knitter-switch

Product Change Notification

Effective date: from production April 2012

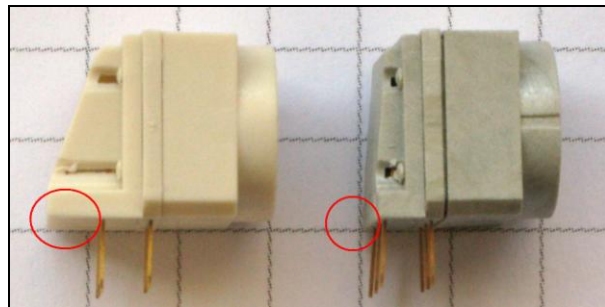
The shape of the back part of the case was modified to allow more effective PCB design.
There are no other changes on these products.
Several data-sheets were amended due to standardization of technical data.

Up to now: large protrusion

From now on: small protrusion
